42 Honeysuckle Drive

Little National, 42 Honeysuckle Drive, Newcastle

State Significant Development (SSD-10378)

DEVELOPMENT MODIFICATIONS

2.1 Design Changes North Elevation

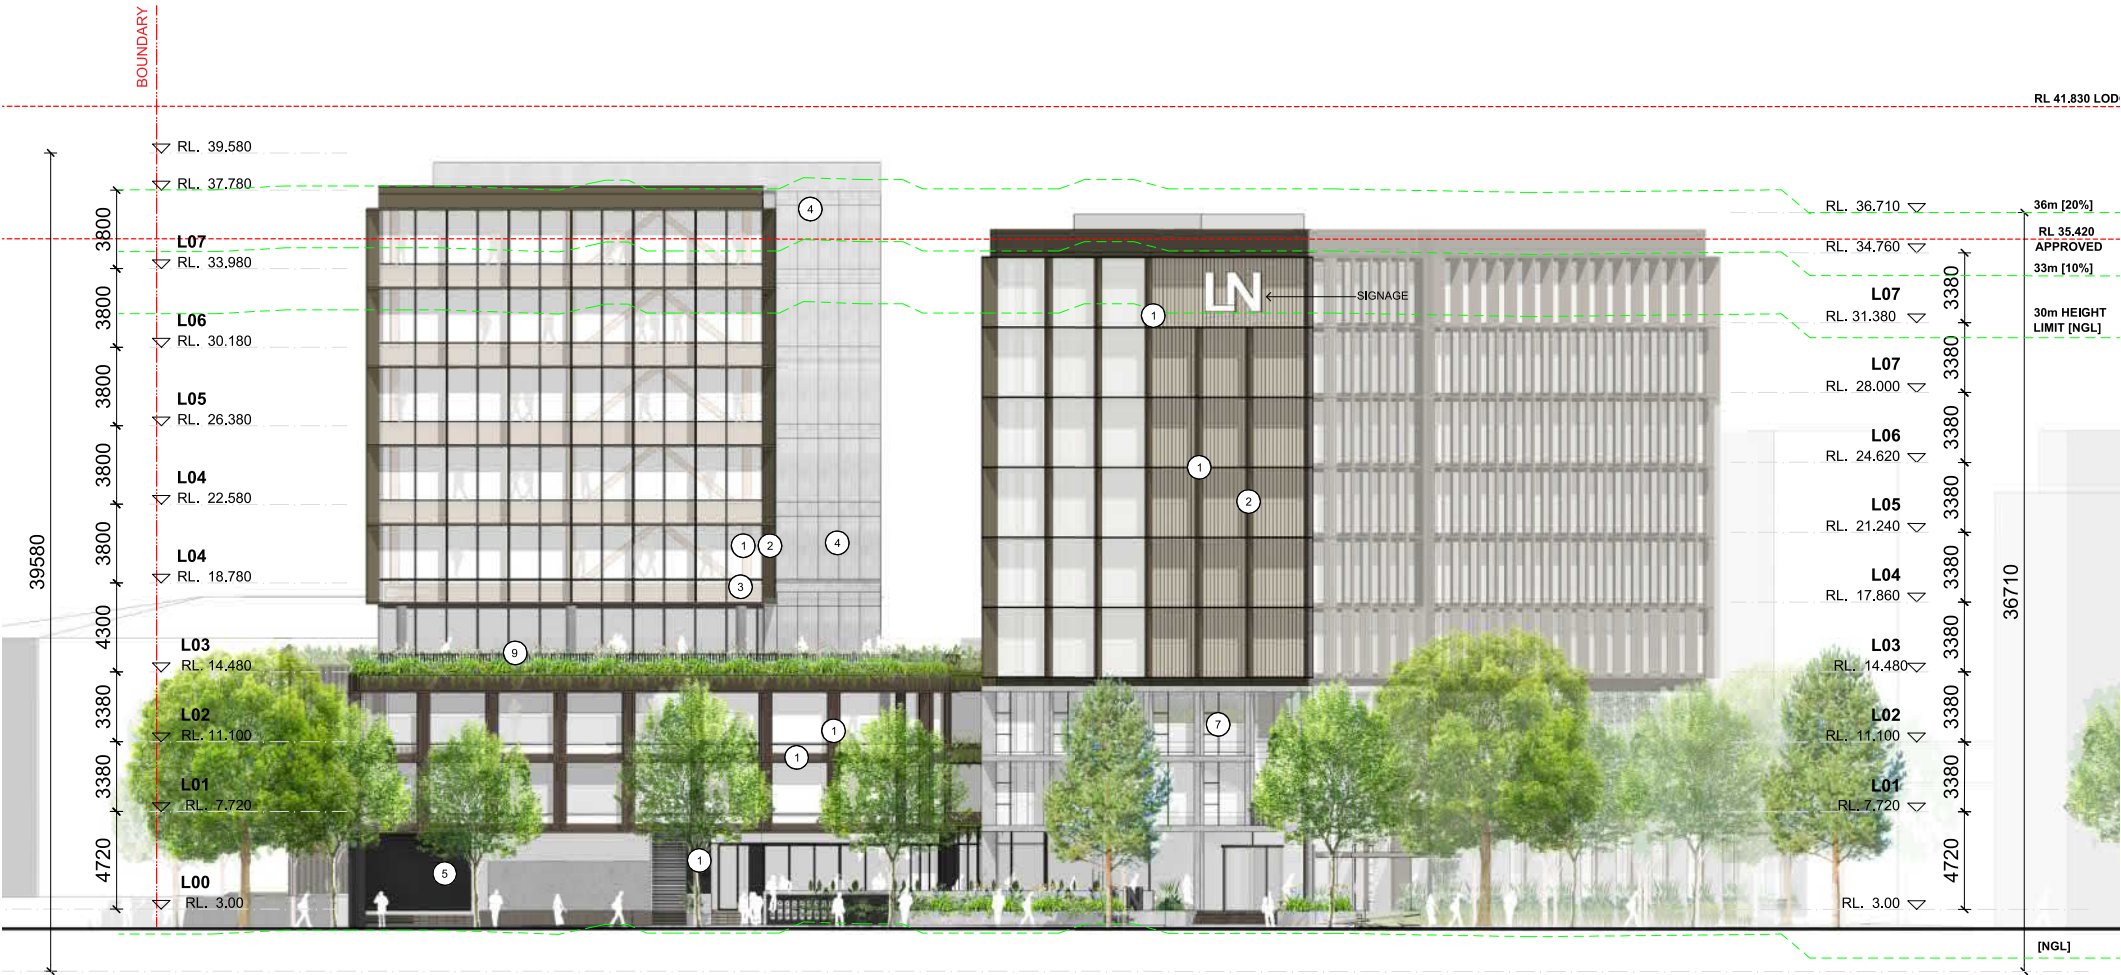
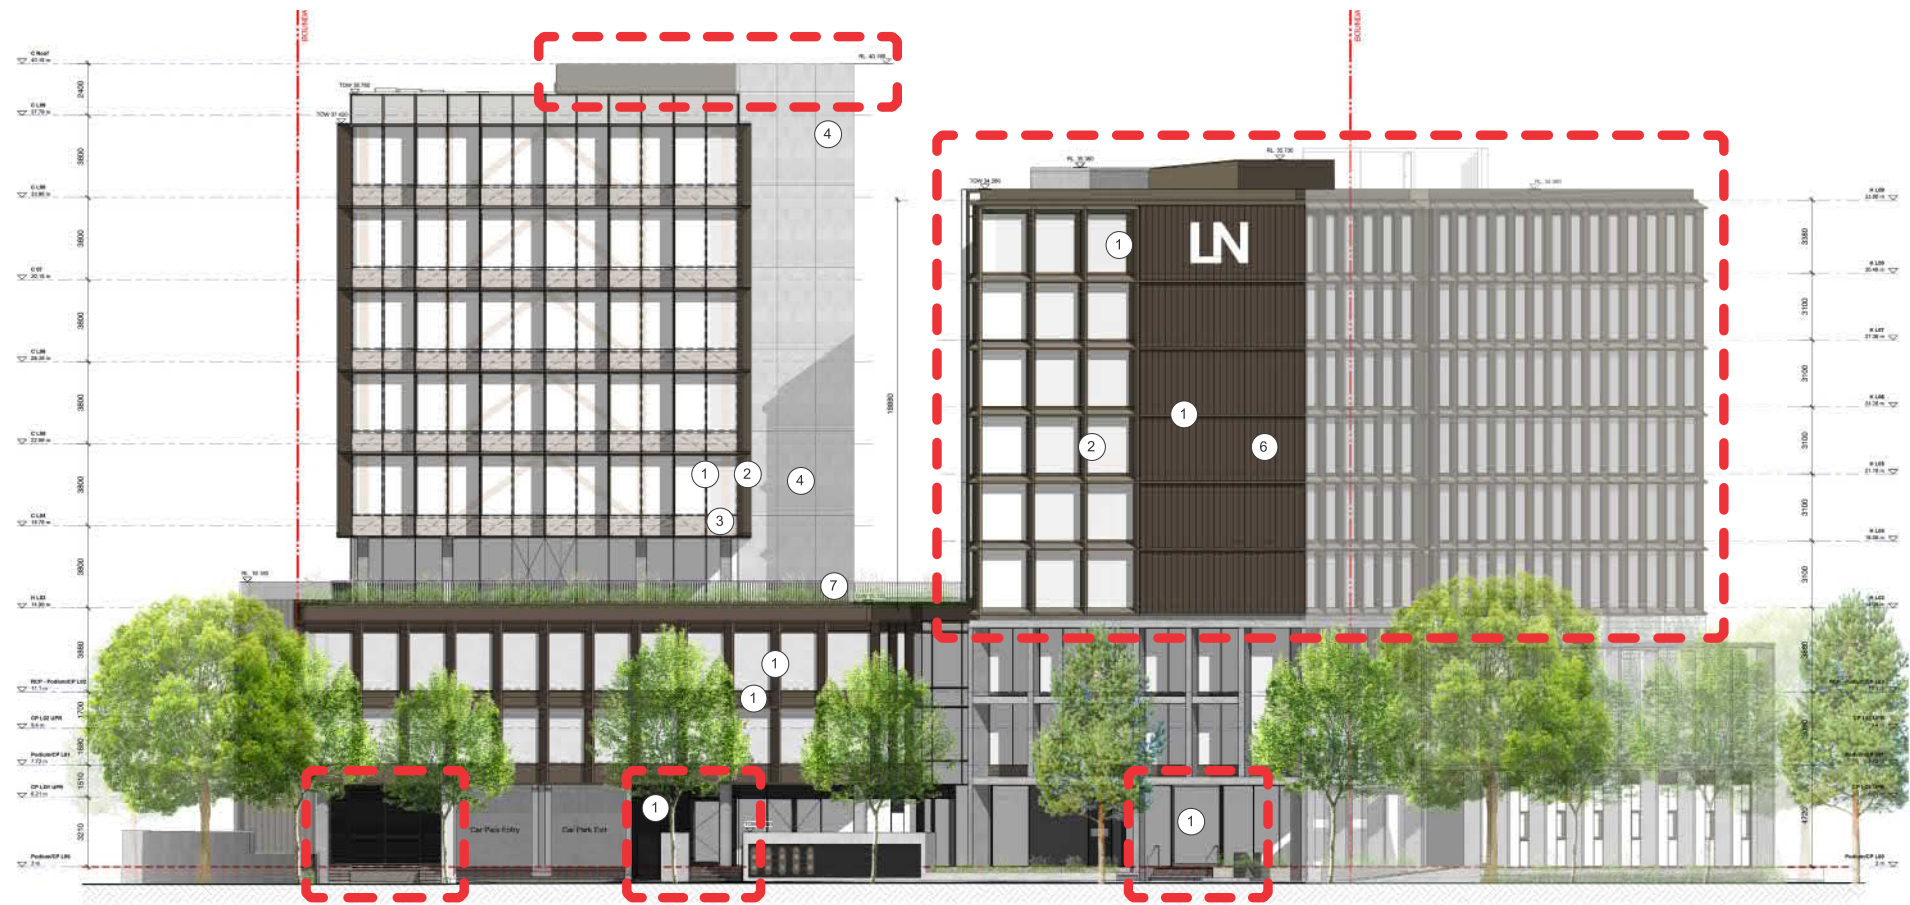
- 1 / Substation location shifted to align with structure over
- 2 / Commercial lobby and associated external access stairs shifted
- 3 / Hotel entry and associated external access stairs shifted
- 4 / Hotel slab to slab levels reduced from 3380mm down to 3100mm. This has resulted in an overall hotel building

- Height reduction.
- 5 / Commercial tower height increased by 600mm to allow for additional plant height
- 6/ Facade materiality remains the same with the exception of the north facade of the hotel facade - some of the fenestration has been removed and the colour moved to a dark bronze..

3.1 Design Changes

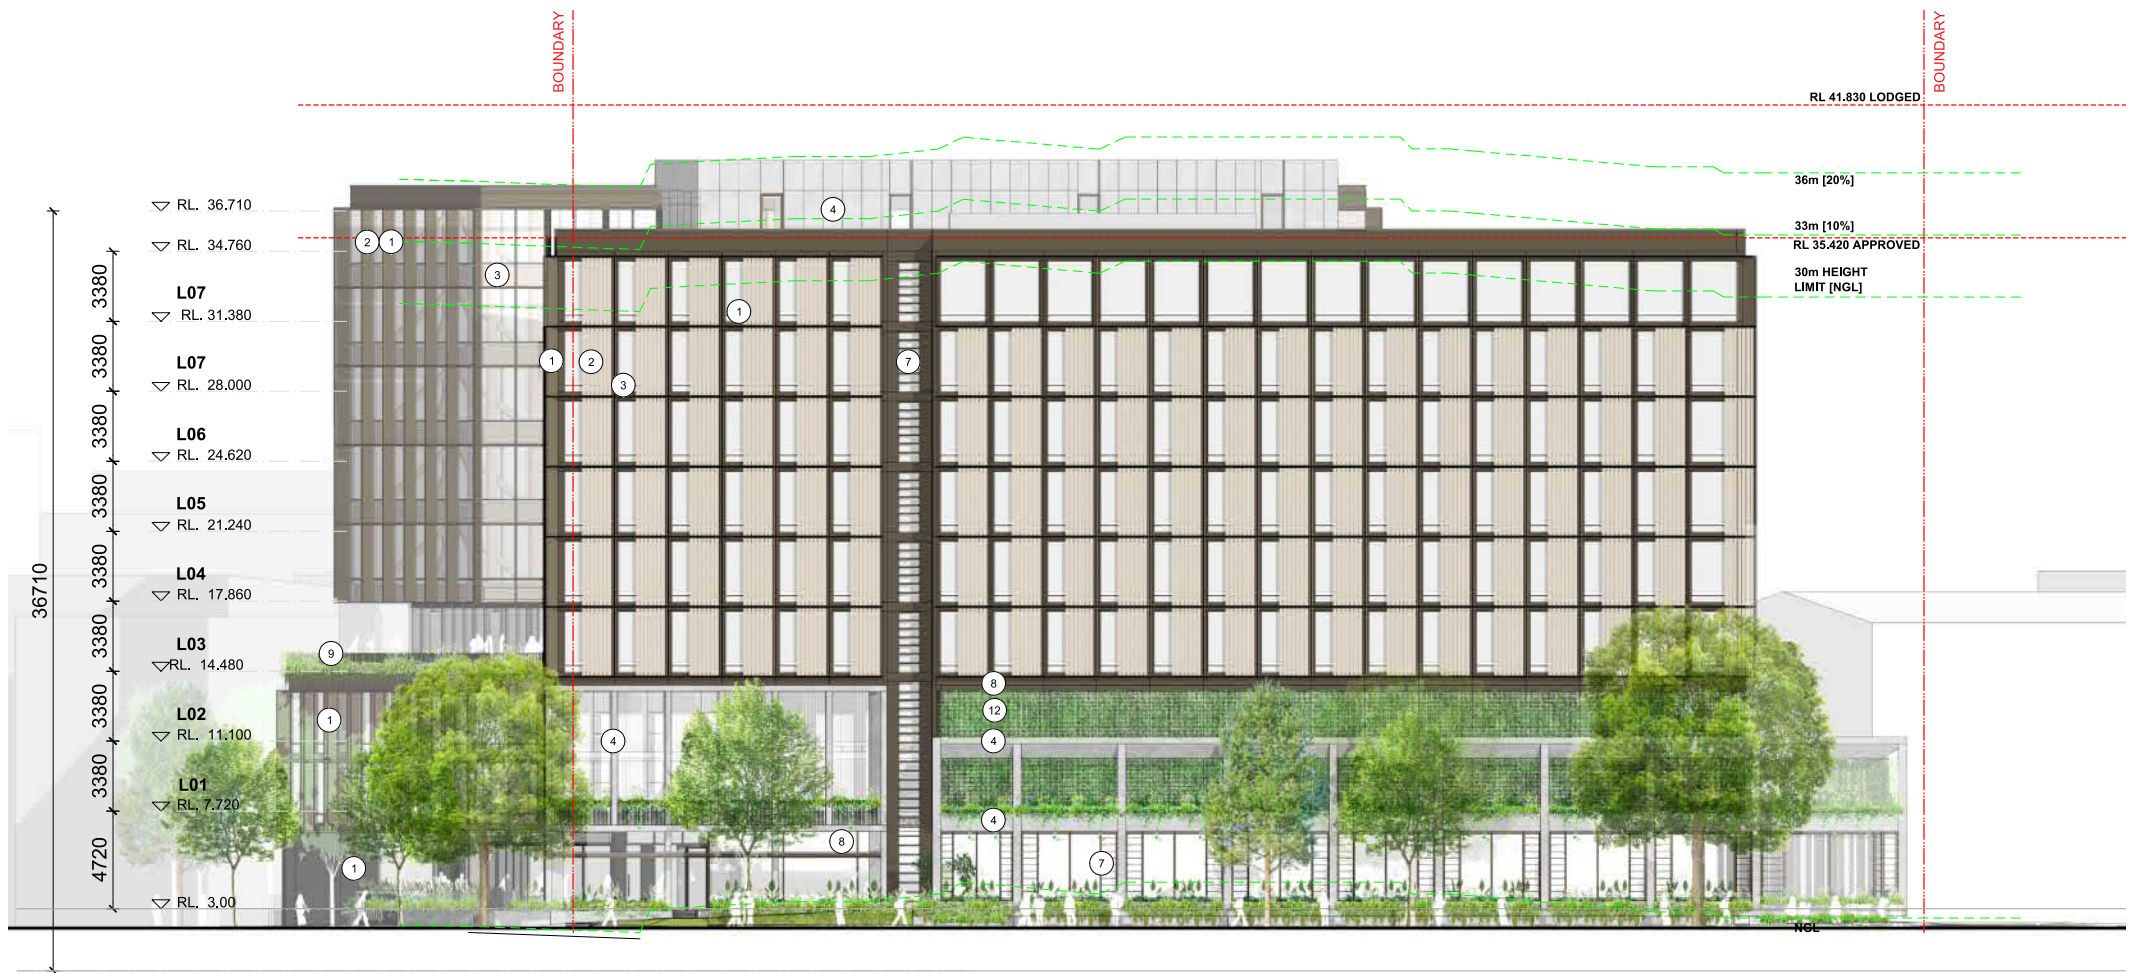
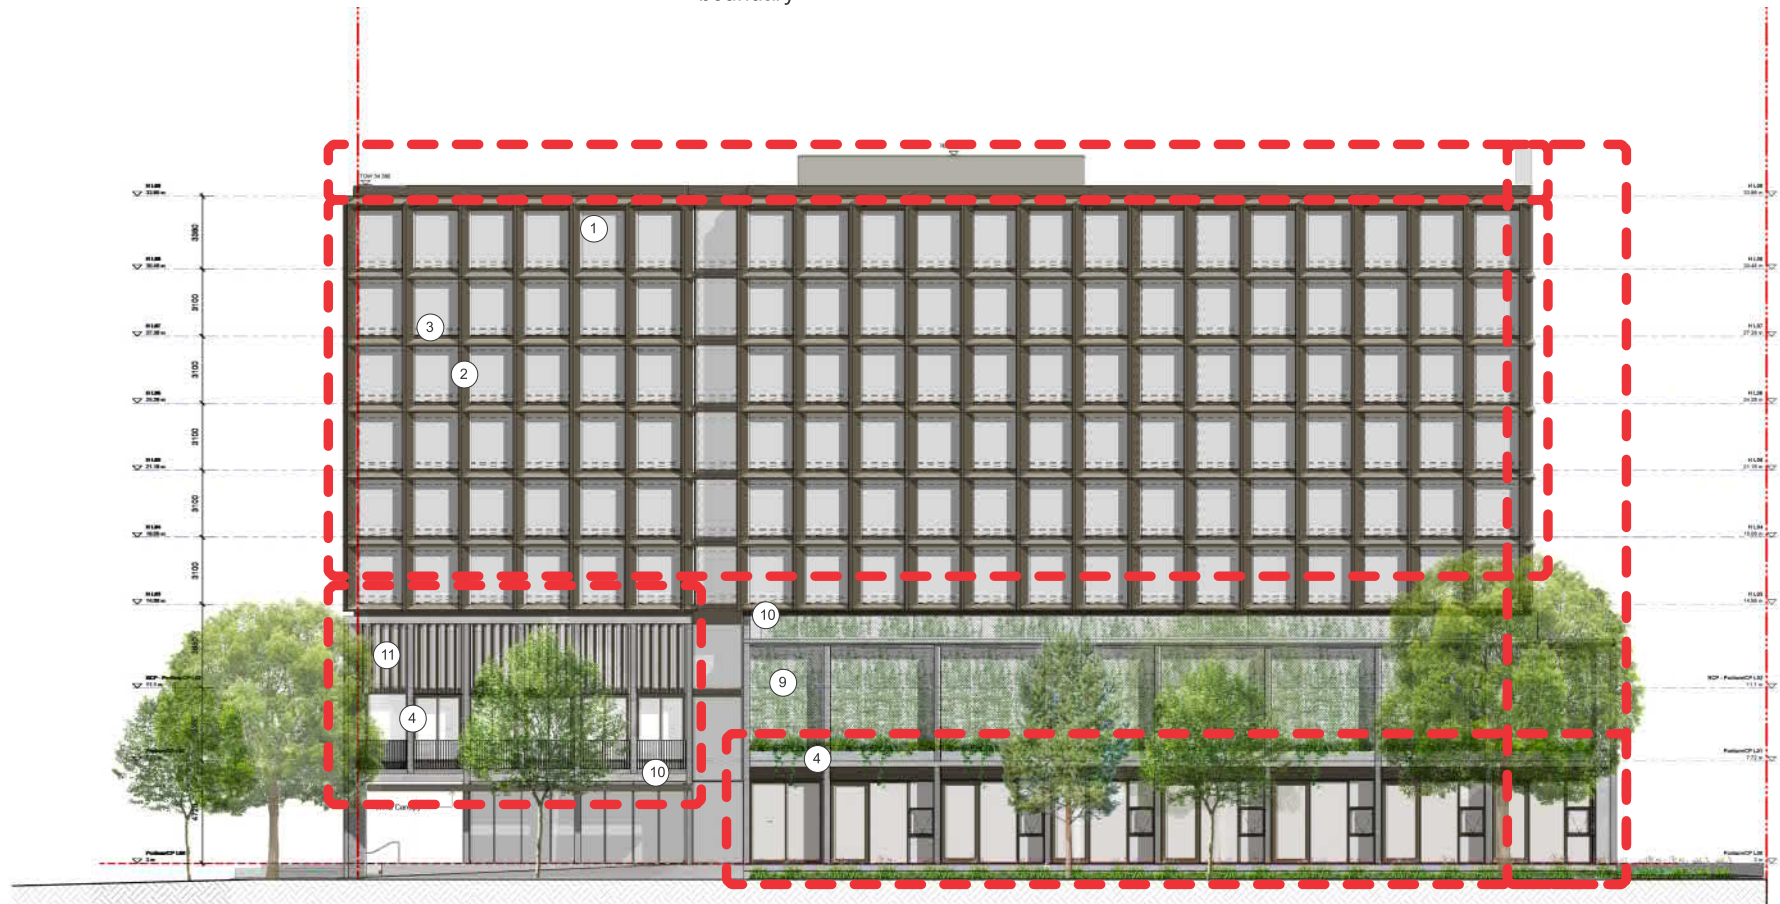
1 / Hotel slab to slab levels reduced from 3380mm down to 3100mm. This has resulted in an overall hotel building height reduction.

2 / L01 and L02 North/west corner amended. External terrace omitted and sun-shading added to level L02

3 / Hotel south end of building has been reduce in length by 1 hotel room width.

4 / Arbor structure has been pulled back at the south boundary.

5/ Ground floor facade to meeting rooms and gym has been amended. Glass louvres removed and sliding doors and operable windows added.

6/ Hotel facade from levels L03 to L08 - external louvres have been omitted and an angled 600mm deep vertical and horizontal sunshade added

7/ Facade colours and materiality remain the same

4.1 Design Changes

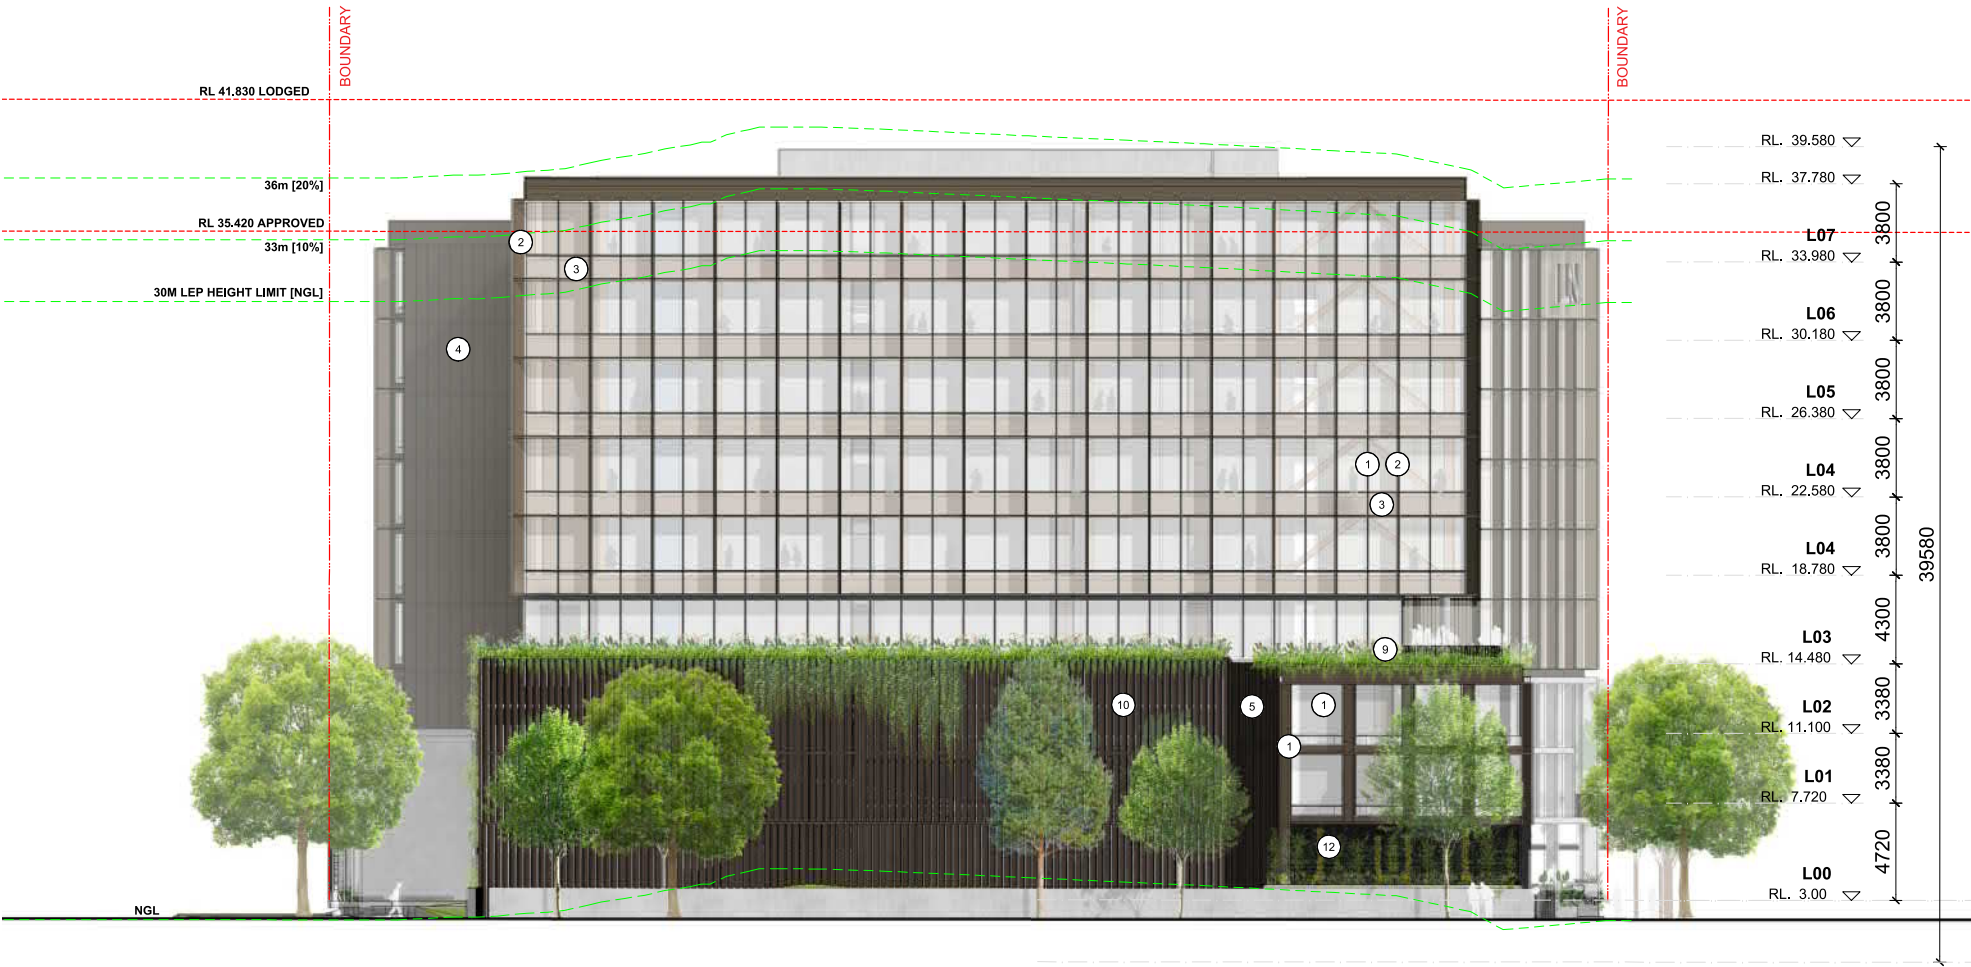
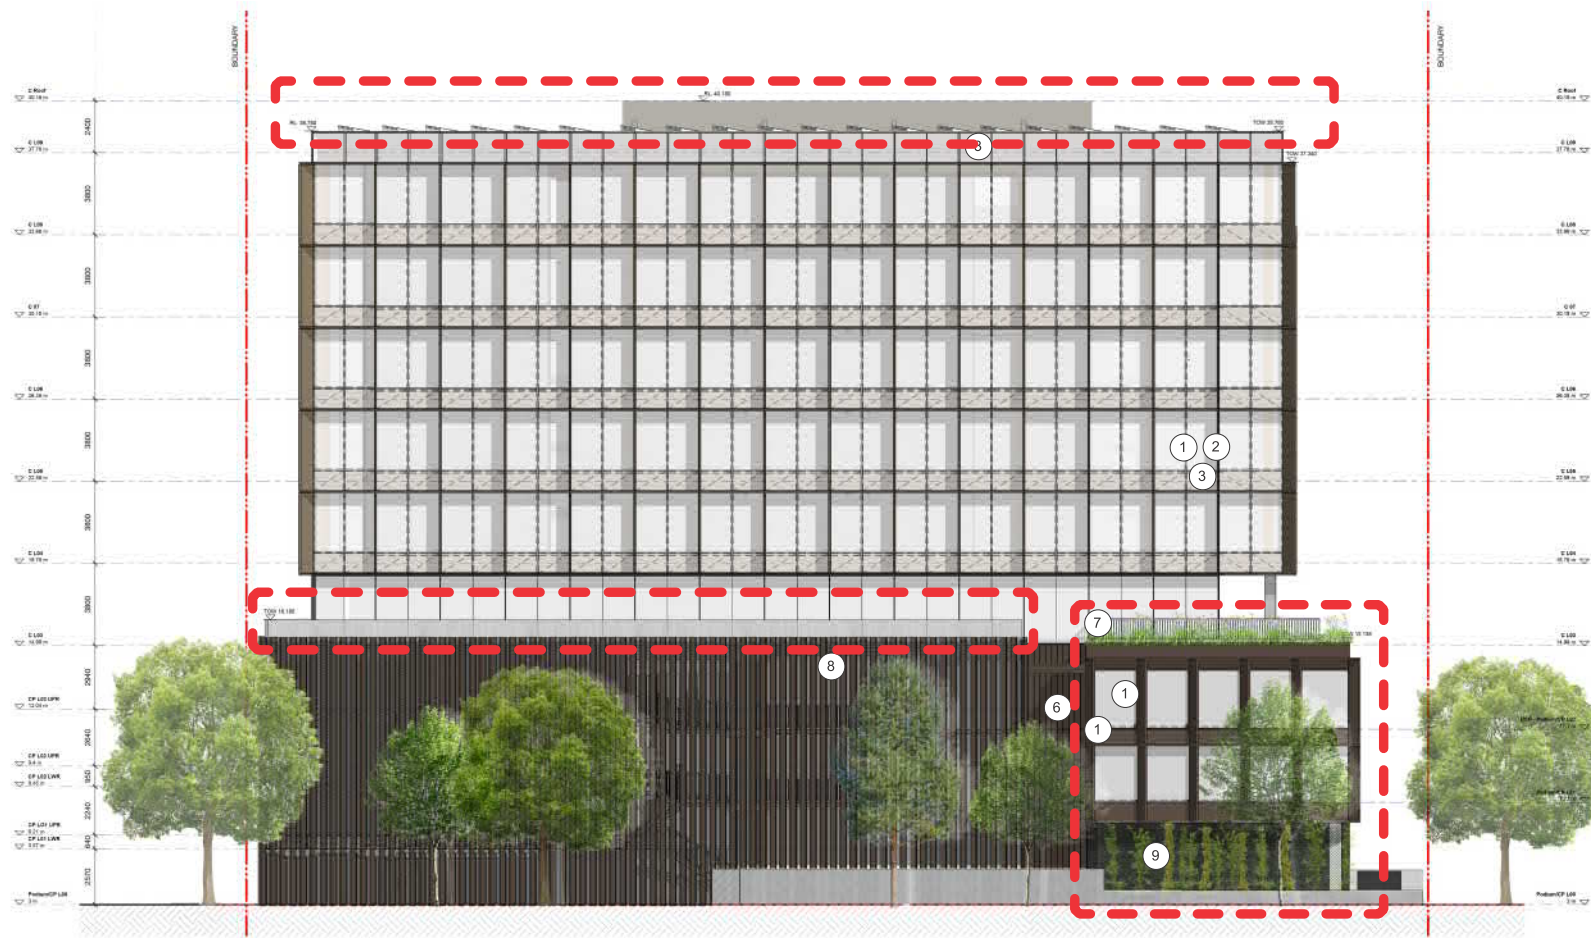
- 1 / Commercial podium levels L01 and L02 facade amended with a singular vertical sunshade expression
- 2 / Commercial tower height increased by 600mm to allow for additional plant height.
- 3 / Perimeter edge planters to Level L03 over carpark omitted
- 4/ Facade colours and materiality remain the same
